The Old Cottage

Condition 4: Method Statement RE: Listed Building Consent 232278

Date: 21.04.26

4.0 WBC FEEDBACK and APPLICANT RESPONSE to previous Condition 4 submission

Fig. 1: Extract from the Clive Hudson Associates' structural report on the west gable

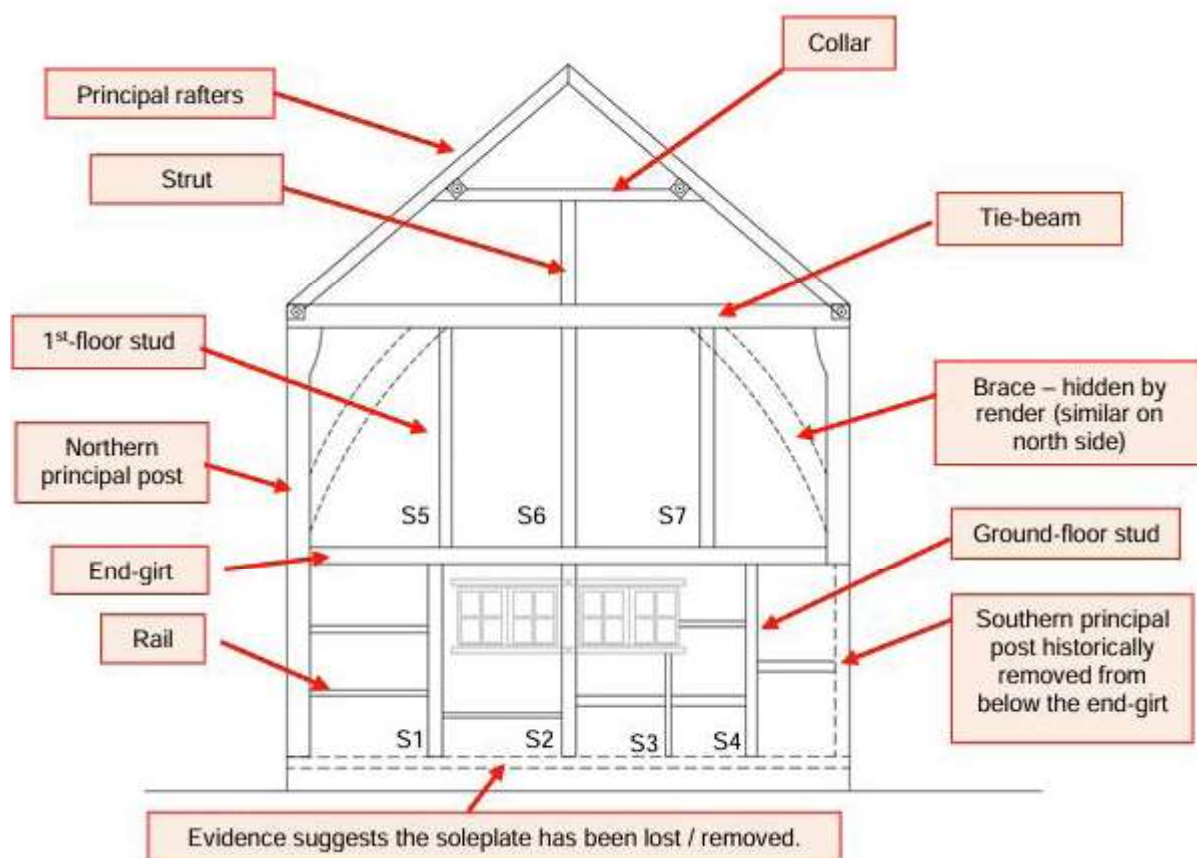
The Clive Hudson structural report on the west gable identifies secondary studs 1-4 as the vertical timber studs at the ground floor between the 'end girt' (see Fig.1 for reference).

In order to repair the timber and re-create the load paths of the original timber frame, three new studs are proposed to replace S1-S4, directly below the first floor studs S5, 6 and 7. The original peg holes on site provide evidence of the original arrangement of vertical posts proposed (refer also to paragraph 4.5.2) ie: the current locations are not the original locations.

4.5.1 *"Regarding timber repairs, the proposal includes removing—rather than reinstating—the historic horizontal rail and vertical studwork below the end girt, replacing them with new studs aligned to those above. No justification is provided for altering the historic arrangement instead of replicating it."*

"Original peg holes on site provide evidence of the original arrangement of vertical posts proposed. Structural engineer advises we could reinstate posts as they exist now or as they were originally doesn't matter structurally. Either option would involve reinstatement/restoration due to timber decay so either approach would seem acceptable in heritage terms."
